Department of Energy

92-WOB-317

REQUEST FOR APPROVAL TO INSTALL LONGER WELL SCREENS IN NON-RADIOACTIVE DANGEROUS WASTE LANDFILL GROUNDWATER MONITORING WELLS

1 Figure 4-18. Historical Water Level Data for Well 699-24-33.

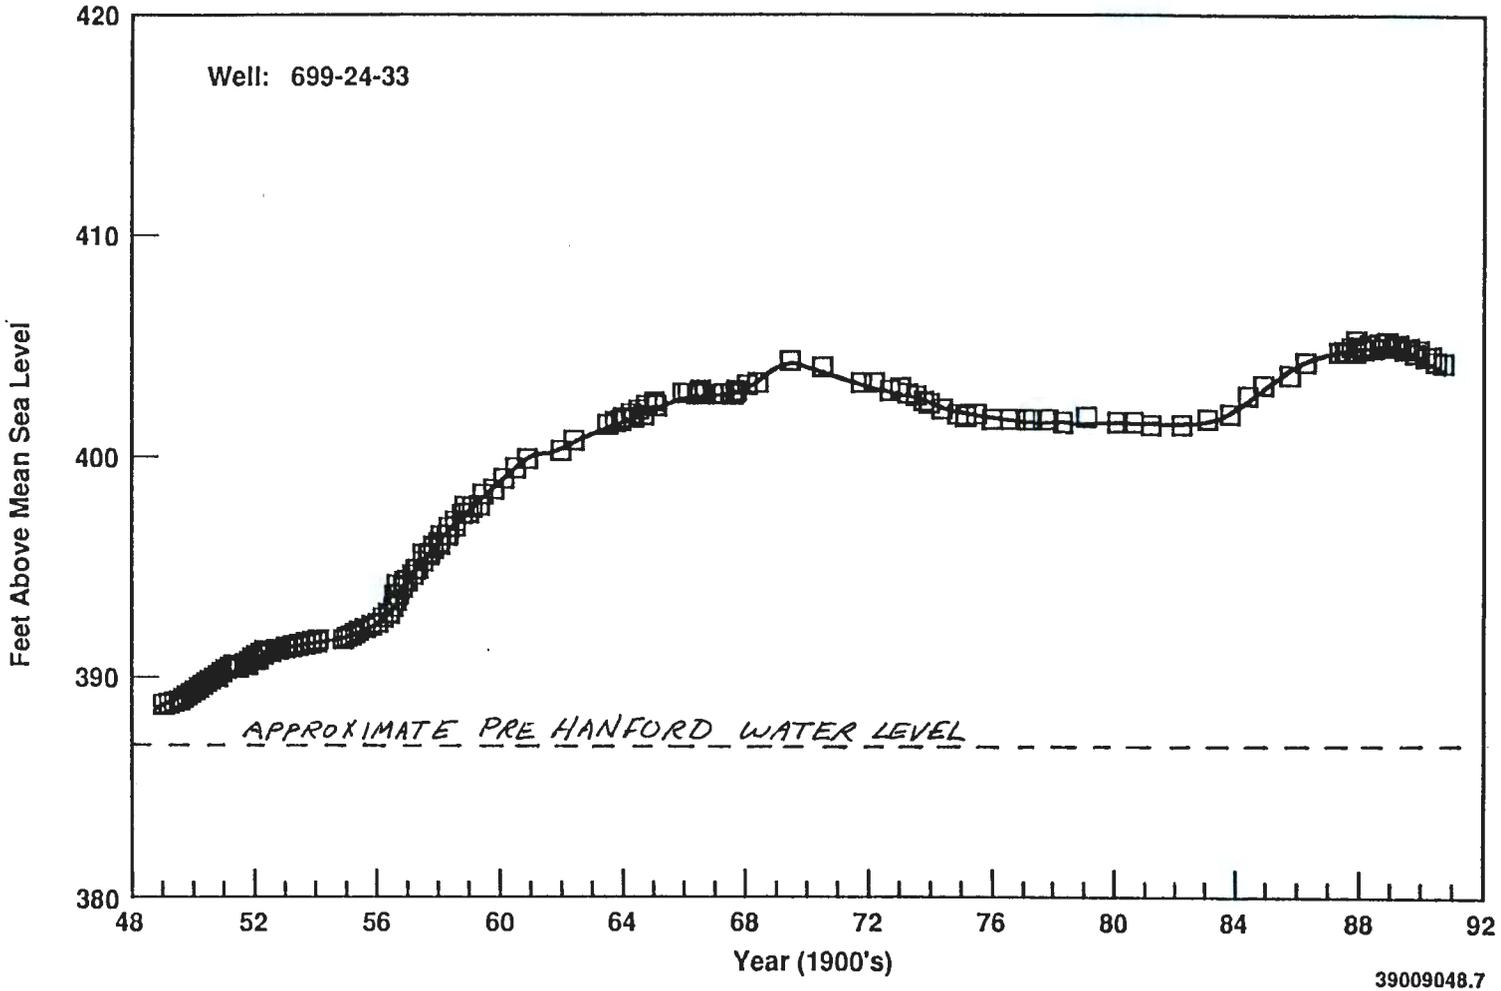
The NRDWL, part of the Hanford Central Landfill Complex, is located approximately 4 km (2.5 mi) southeast of the southeast corner of the 200 East Area of the Hanford Site (Enclosure 1). Liquid effluent discharges, principally in the 200 East Area, have resulted in a rise in the water table beneath the NRDWL of at least 17 feet since 1944. This increase in water table elevation is illustrated by the hydrograph of well 699-24-33 (Enclosure 2). Well 699-24-33 was completed in 1948 and is located approximately 500 feet east of the adjacent Solid Waste Landfill (Enclosure 3).

Figure 18-3. Hydrographs of Monthly Water Level Measurements (Feet Above Mean Sea Level) at the Nonradioactive Dangerous Waste Landfill.

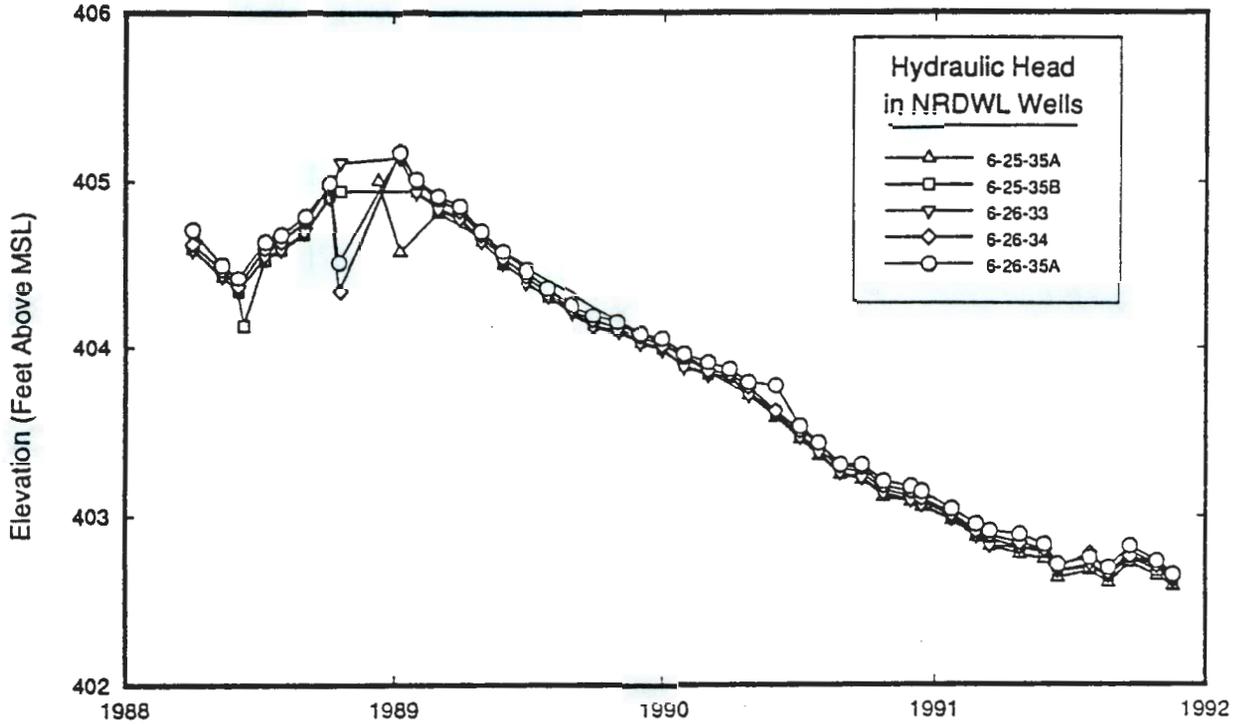
The water table at the NRDWL has decreased by approximately three feet since the end of 1988, principally as a result of decreased effluent discharge to B-Pond (216-B-3). This decrease is shown by the hydrograph for the five top-of-the-water table wells at the NRDWL (Enclosure 4). If water table decline continues at the current rate water levels will drop below the bottoms of the screens on the existing monitoring wells at the NRDWL in approximately ten years and the wells would become unusable prior to that time.

Because of the magnitude of water table decline at the NRDWL it is prudent to install longer screens in new wells at the NRDWL. The increased screen length will greatly extend the useful life of the wells and may eliminate the need for future replacement of these wells. On this basis it is recommended that 35 foot screens be placed in all new wells at the NRDWL and that the screens be placed so that five feet of the screen extends above the water table.
